Palo Verde Nuclear
Generating Station

**Subject: Palo Verde Nuclear Generating Station (PVNGS)
Unit 2, Docket No. STN 50-529
Response to Request for Additional Information Regarding Steam
Generator Replacement and Power Uprate License Amendment
Request**

**NRC Plant Systems Branch
Questions and APS Responses**

Figure 10-1: Revised Figure 6.2-13
MSLB Outside Containment for Equipment Qualification at 3990 MW_t

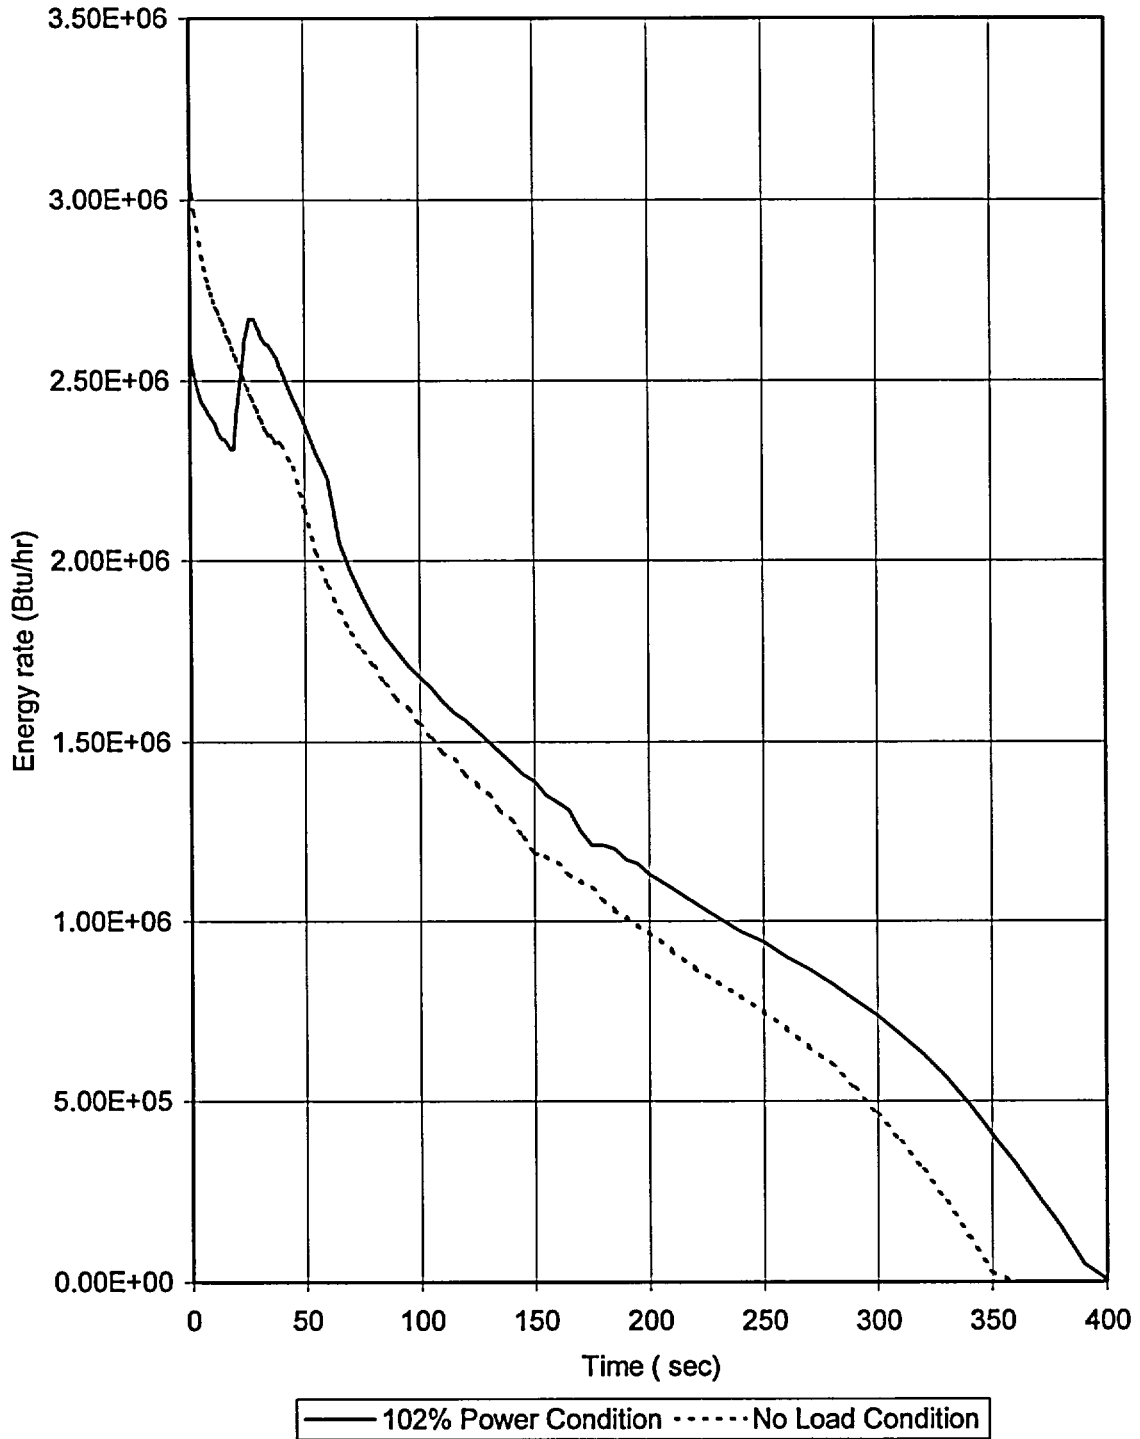
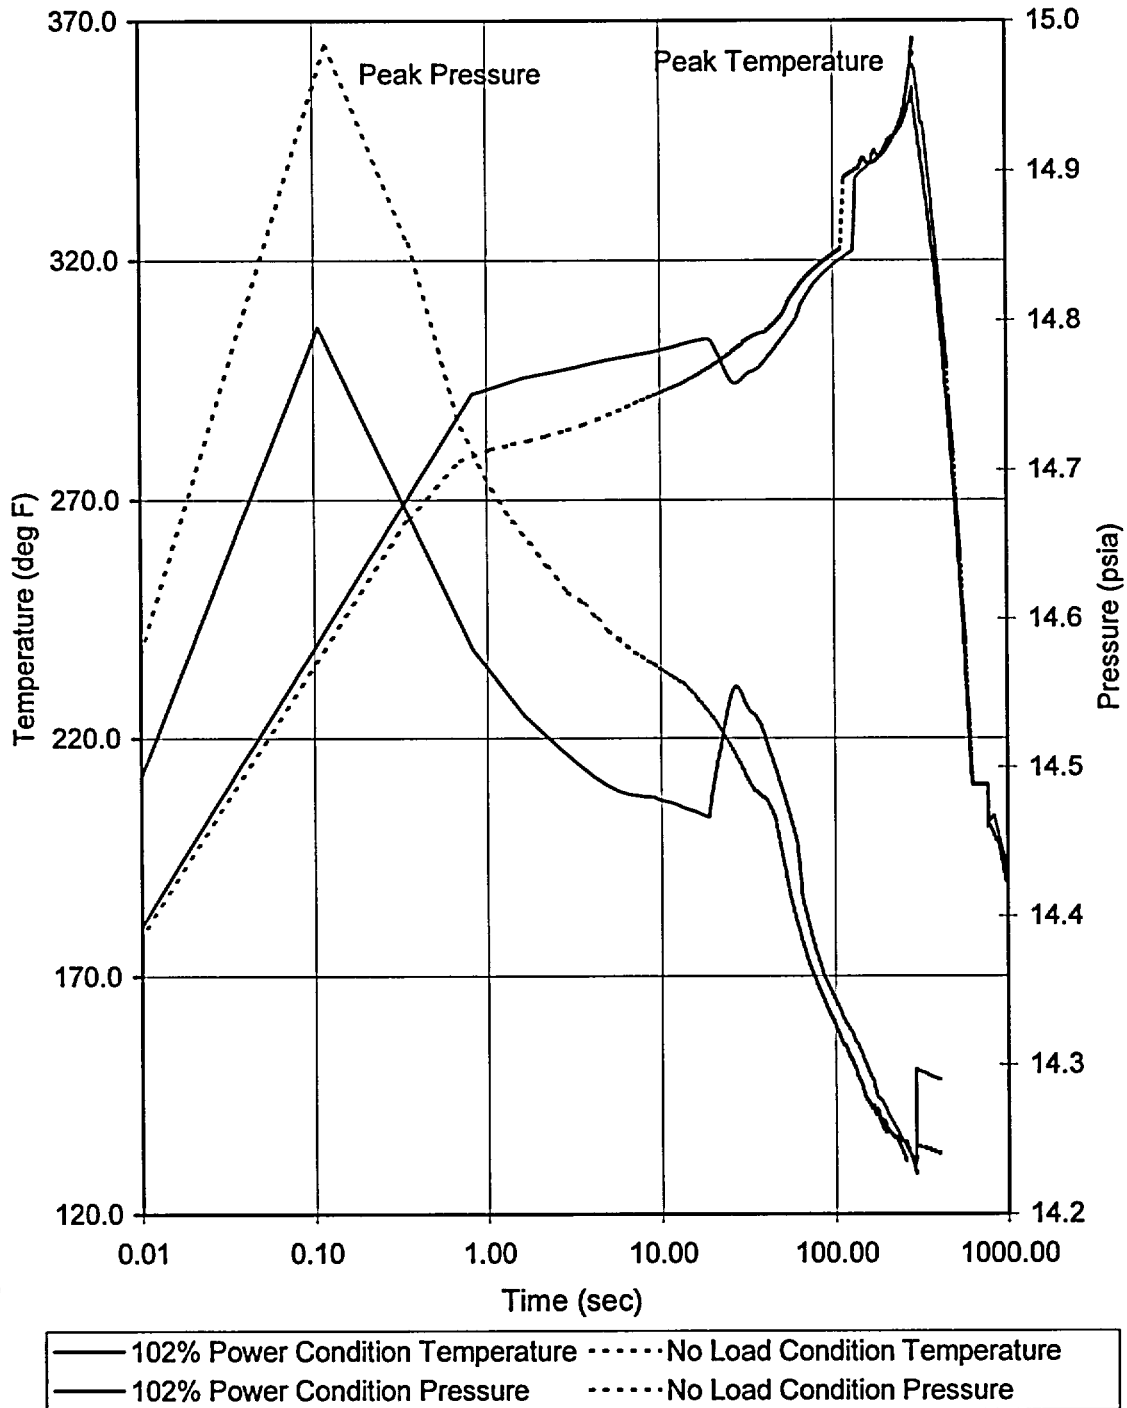
In the submittal, it is stated that "Figure 6.2-13 provides comparison plot, of current versus proposed power, of rate of energy discharge to compartments containing breaks at zero and 4070 MW_t (102% of 3990 MW_t)." It appears that the figure provides a comparison of the 0 percent and 102 percent energy discharged at the PUR power and does not provide a comparison of the current versus proposed power. Please clarify. For the limiting case, provide the comparison plot of the energy discharged from the break.

The text of the PURLR submittal requires clarification, the first paragraph of Section 6.2.4.4, page 6-30, should read:

The mass and energy (M&E) release for a 1 ft² MSLB outside of the containment was calculated using the SGNIII code. The results were used to calculate the potential effects of a MSLB on essential equipment outside of containment using code PCFLUD (Reference 6-43). Figure 6.2-12 provides a comparison plot, of current versus proposed power, of mass release rate versus time. Figure 6.2-13 provides a comparison plot, of rate of energy discharge to compartments containing breaks at 0% and 102% of requested power level. Pressure and temperature profiles for the most limiting compartment are presented in Figure 6.2-14. Table 6.2-7 provides a comparison of the results of a 1 ft² SLB outside containment. As it can be deduced, the change in code modeling results in more realistic pressure and temperature profiles. The peak temperature and pressure for the event remain bounded by the existing analysis.

Figures 6.2-13 and 6.2-14 titles and captions have been revised and are provided in Figures 10-1 and 10-2. Figure 10-3 provides a comparison plot of the limiting (no load) condition energy discharge for current and PUR conditions.
